Access Compliance Report

Public Rights-of-Way

(Curb Ramps)

Intersection ID: 43676	Main Street: SARDIS_COMMONS_LN	Cross Street: SARDIS_RD	Location: E
ADA ID: F5B5C0DA9CDC	Ramp Type: PerpDiag	Initial Pass/Fail: Fail	Overall Compliance: No
Severity Score: 46.25			
Codes/Mitigation Info/Possible Solution		Field Measurements/Component Compliance

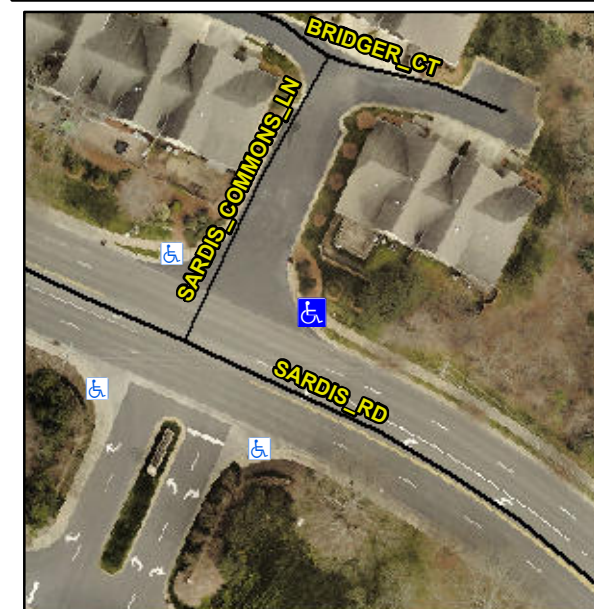
Not Found, R304.5.1, R304.2.2, R304.5.3

Compliance	Description	Data	Compliance	Description	Data
N/A	Ramp Length (in)	47.5	No	Ramp Slope (%)	8.4
No	Ramp Width (in)	43.0	No	Ramp XSlope (%)	7.2
N/A	Flare Type LT	N/A	N/A	Flare Type RT	N/A
N/A	Flare Slope LT (%)	N/A	N/A	Flare Slope RT (%)	N/A
N/A	Flare Traversable LT?	N/A	N/A	Flare Traversable RT?	N/A
N/A	Landing Length (in)	N/A	N/A	DWS Provided?	N/A
N/A	Landing Width (in)	N/A	N/A	DWS Contrast?	N/A
N/A	Landing Slope (%)	N/A	N/A	DWS Length (in)	N/A
N/A	Landing X Slope (%)	N/A	N/A	DWS Full Width?	N/A
N/A	Landing Curb? (Y/N)	N/A	N/A	DWS Offset (in)	N/A
N/A	Shared Landing?	N/A			
N/A	Gutter Ponding?	N/A	N/A	Gutter Slope (%)	N/A
N/A	Gutter Lip Ht (in)	N/A	N/A	Gutter X Slope (%)	N/A
N/A	Painted X Walk1?	No	N/A	Painted X Walk2?	No
	X Walk 1 Direction	To NW		X Walk 2 Direction	To SW
N/A	X Walk 1 Width (in)	N/A	N/A	X Walk 2 Width (in)	N/A
	X Walk 1 Slope (%)	4.0		X Walk 2 Slope (%)	4.1
	X Walk 1 X Slope (%)	4.9		X Walk 2 X Slope (%)	5.5

Remove & Replace Curb Ramp With Two New Directional Ramps or Equivalent.
